Regional Center Approval to provide for overall site design approval, including a campus vehicular plan, art locations, pedestrian connections, bicycle parking locations, site lighting, and two surface parking lots, with 300 spaces.

# STAFF REPORT

<b>Case Number</b>	2023-REG-070
<b>Address (approx.)</b>	227 and 333 West 14 <sup>th</sup> Street, 323 West 15 <sup>th</sup> Street, 269 and 355 West 16 <sup>th</sup> Street, 1330, 1355, 1410, 1420, 1421, 1515 and 1520 North Senate Avenue, 1234, 1255, 1302, 1310, 1318, 1402, and 1420 North Capitol Avenue
<b>Location</b>	Center Township, Council District # 11
<b>Petitioner</b>	Indiana University Health, Inc., by J. Murray Clark
<b>Zoning</b>	CBD-S (RC)
<b>Request</b>	Regional Center Approval for provide for overall site design approval, including a campus vehicular plan, art locations, pedestrian connections, bicycle parking locations, site lighting, and two surface parking lots, with 300 spaces.

## Site Lighting

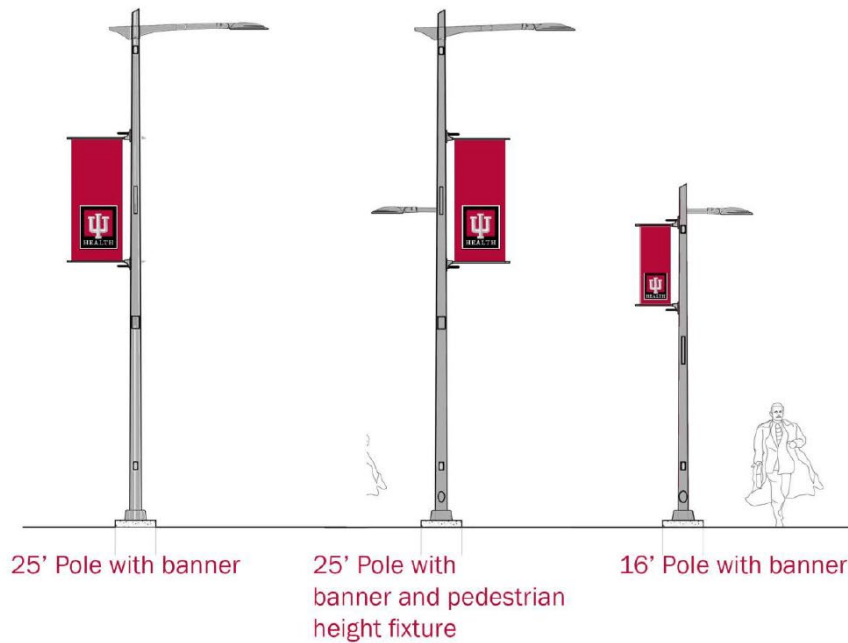
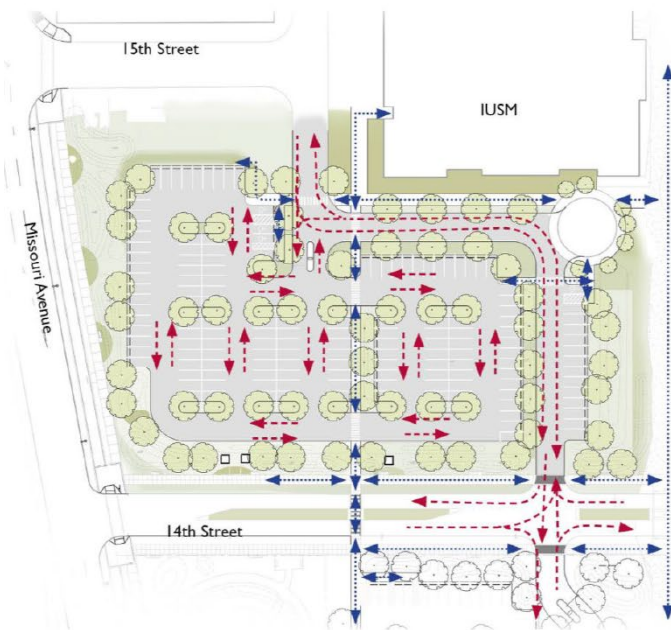
3. A lighting plan was not submitted to the file to identify the location of lighting standards. Additionally, a photometric plan has not been submitted to the file. A photometric plan should detail light standards and photometric levels for the site and at each entrance. Lighting must be provided at each entrance and must be dusk to dawn. Only full cut and shielded light standards are permitted with minimum foot-candle power outlined in CA 4.3.2 and CA 4.3.3. Pedestrian areas and entries must be lighted for safety (CA 3.1.3 and CA 4.3.1). A lighting and photometric plan shall be submitted and subject to planning staff review and approval, prior to installation.

## North Parking Lot

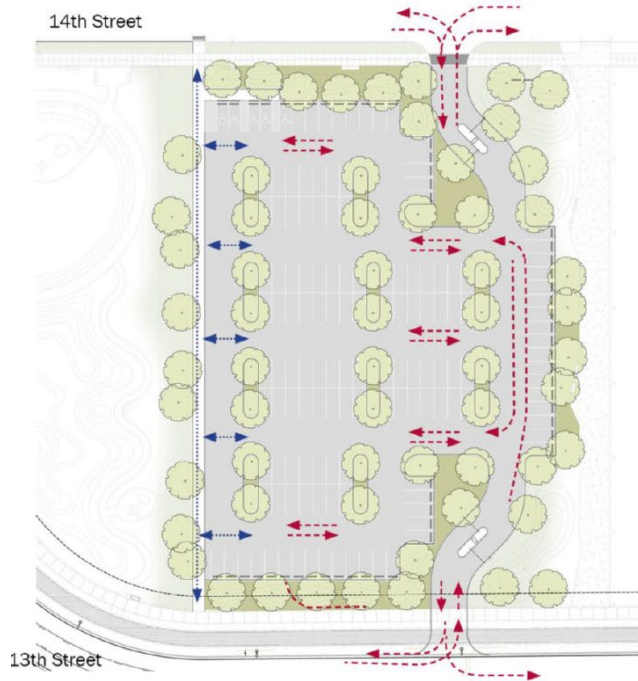
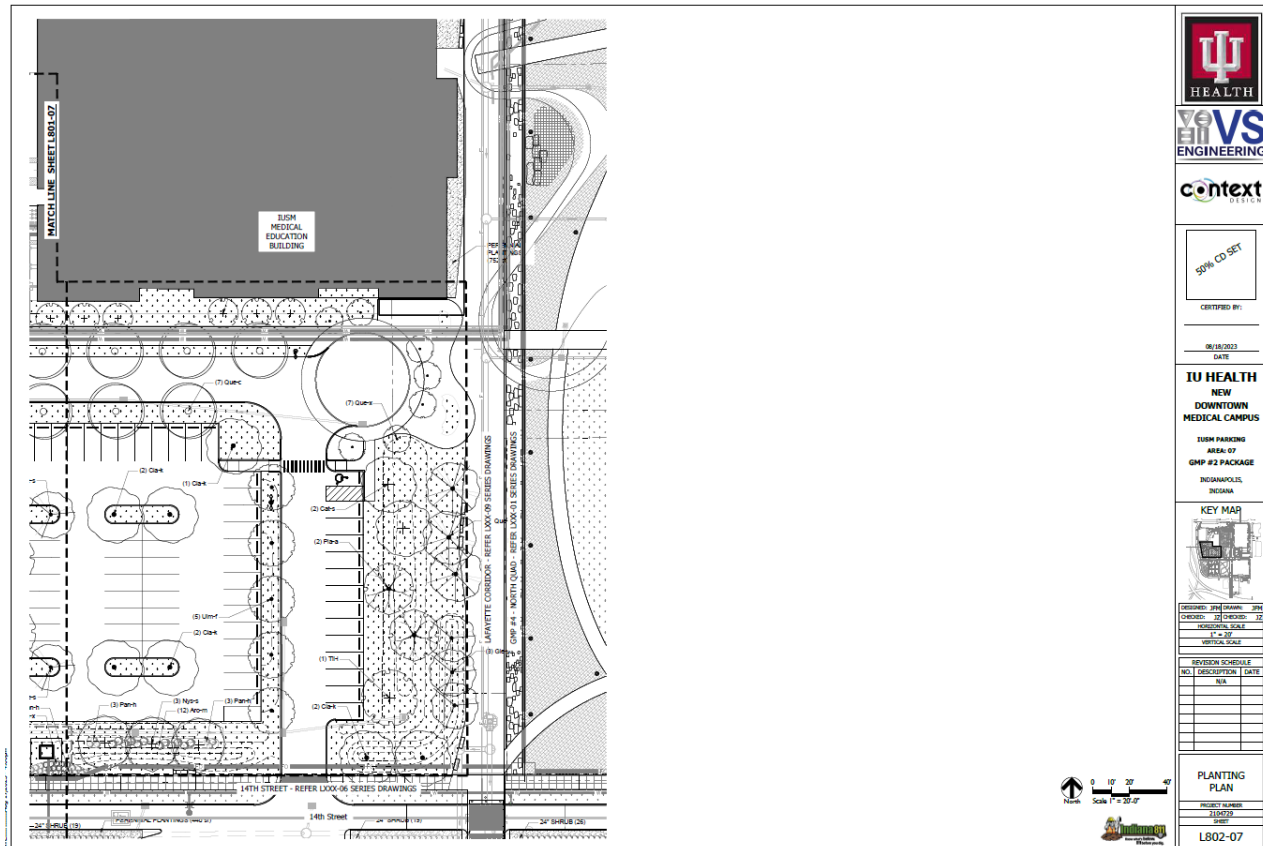
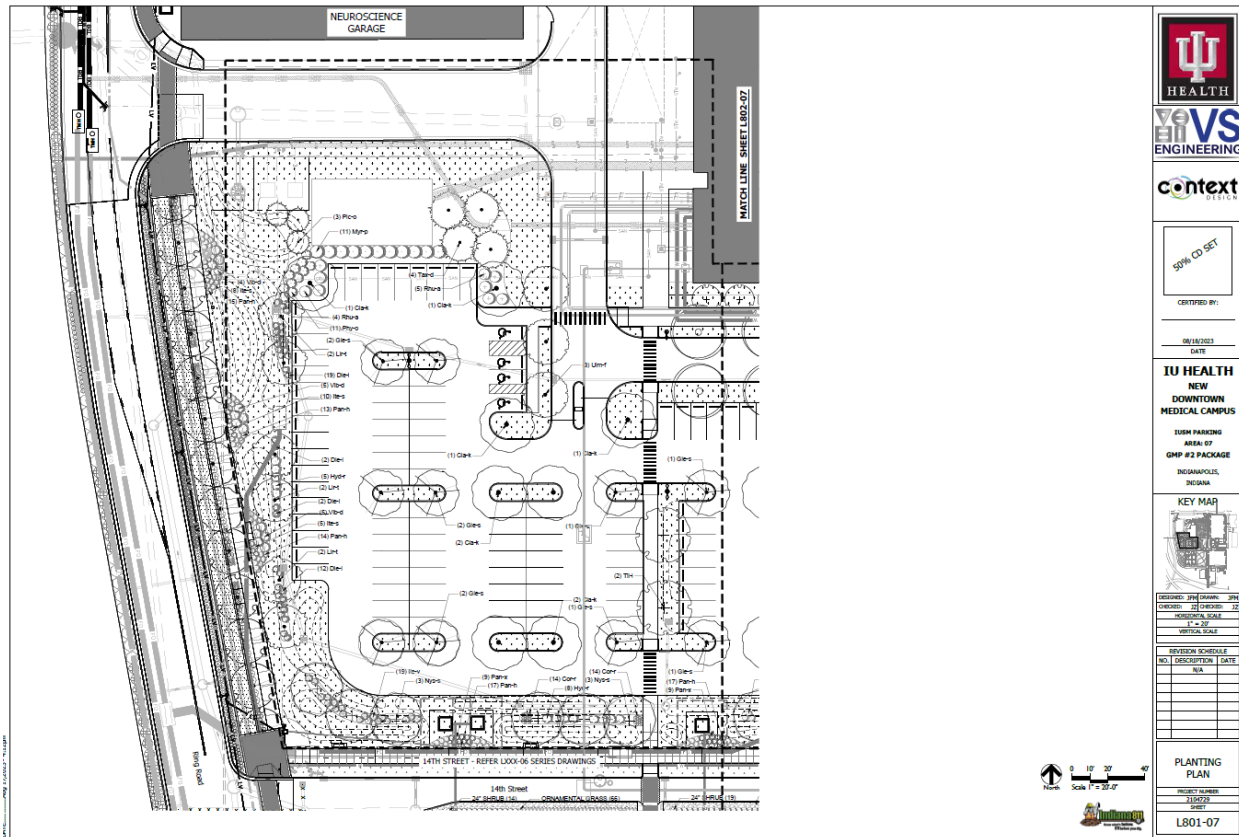
1. Both proposed surface parking lots were planned for structures, according to the approved Master Plan for this site, through 2020-CZN-833. Therefore, these lots should be developed, in time, with structures. Staff would require a timeline for removal of these surface parking lots and development of the lots and for a commitment be placed upon approval of this request. (Guidelines SC 3.1.1, SC 3.2.1 and SC 3.4.1 apply).
